UNITED STATES PATENT AND TRADEMARK OFFICE

09/896,365

Office Action Summary

DETAILED ACTION

ATTACHMENT

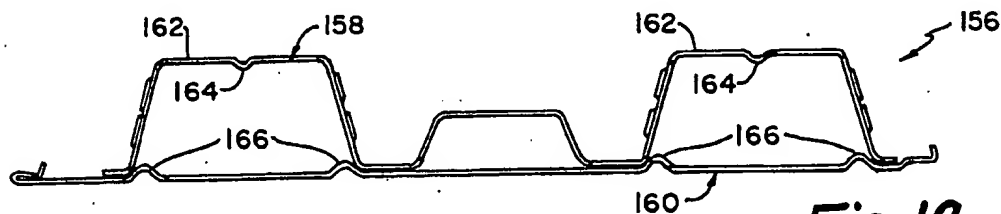
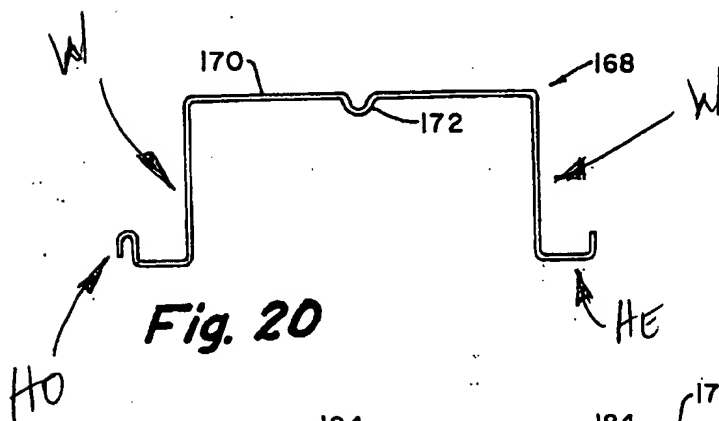
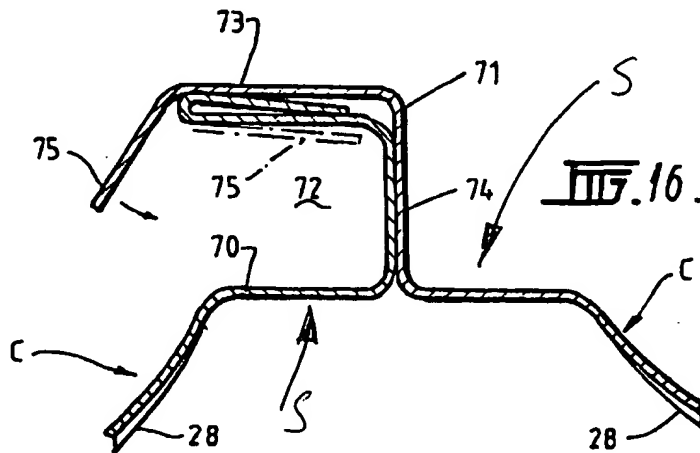
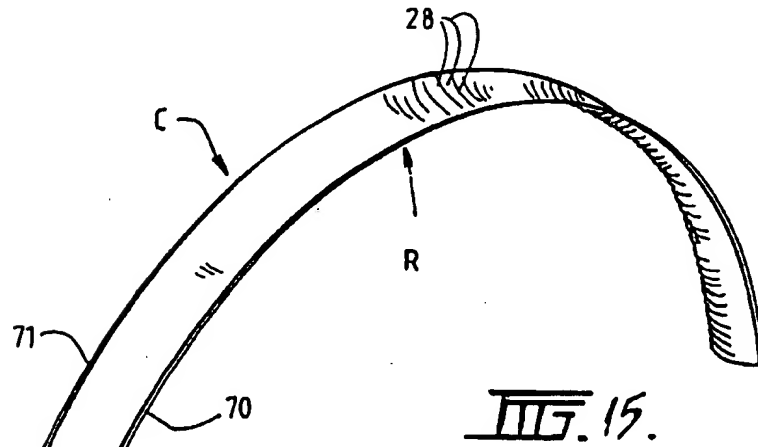
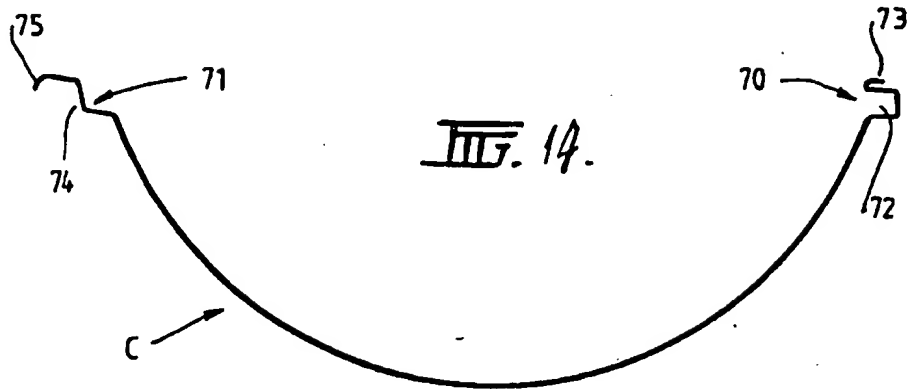
Claims 1-3,8,9,14,15-17,19 and 20 are rejected under 35 U.S.C. 102(b) as being anticipated by US #6,282,936 to BLAZLEY. Regarding claims 1 and 15, BLAZLEY discloses the use of panel member including a curved central portion (C) having a pair of side walls (S) extending therefrom wherein the side walls end in a pair of complementary wings (70,71), see the marked attachment. Regarding claims 2,3,16

and 17, the curved portion (C) is concave and resembles an arc. In reference to claims 8,9 and 19, BLAZLEY discloses that the depth of his arc is 300mm which converts to 11.8 1 inches. Hence, the length of the arc of BLAZLEY falls within the requirements of the claims 8,9 and 19. Regarding claims 14, 20, and in further regards to claim 15, the wings (70,71) of BLAZLEY are disposed on opposing sides of the curved central portion (C) and include a hook portion (75) on one side and a hem portion (73) on the other side such that a wing portion of one side of the panel is connected to another wing portion on a second side of an adjacent panel.

1884709

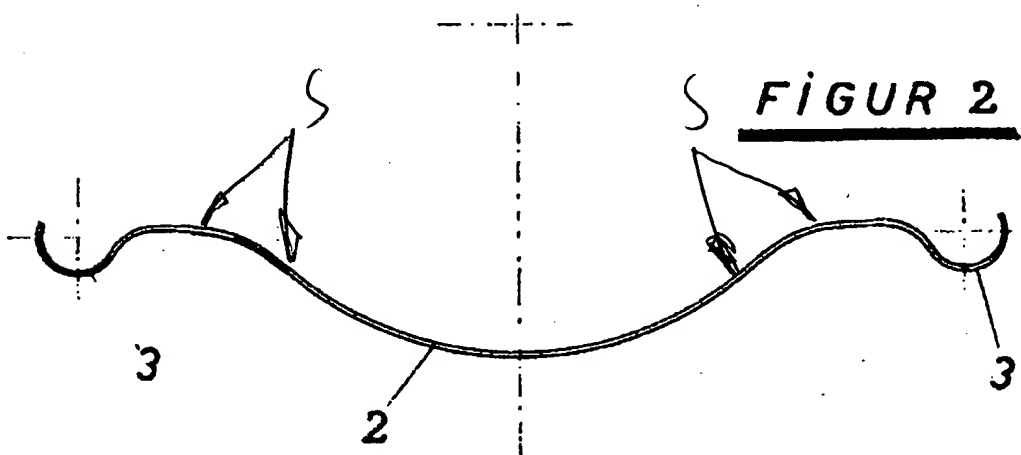
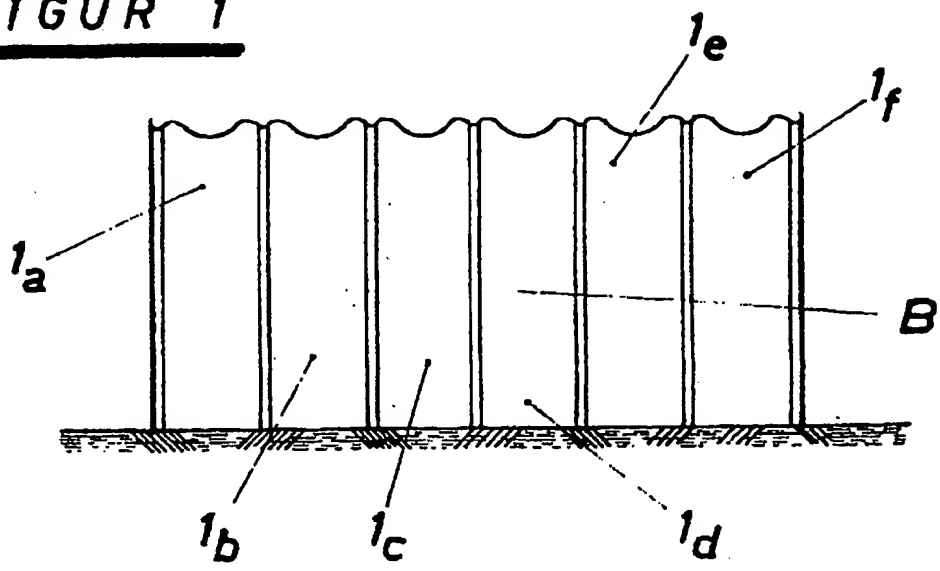
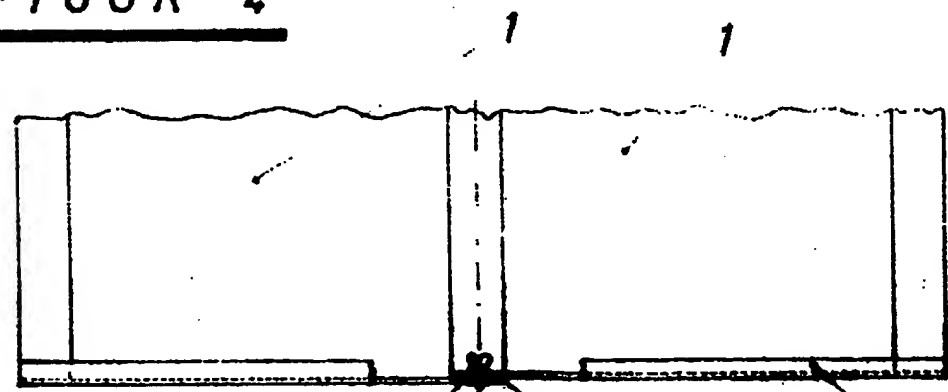
Claims 1,12 and 13 are rejected under 35 U.S.C. 102(b) as being anticipated by German Patent 1684709 or British Patent 770062. In reference to claim 1, German Patent 1684709 or British Patent 770062 both discloses a building panel including a curved portion (3) or (8) having a pair of side walls (S) or (5,7) and a pair of complementary wings (3) or (9,10). Regarding claim 12, the side walls (S) or (5,7) extend at an incline to the curved portion (3) or (8). In reference to claim 13, the side walls (S) or (5,7) extend tangentially to the curved portion (3) or (8).
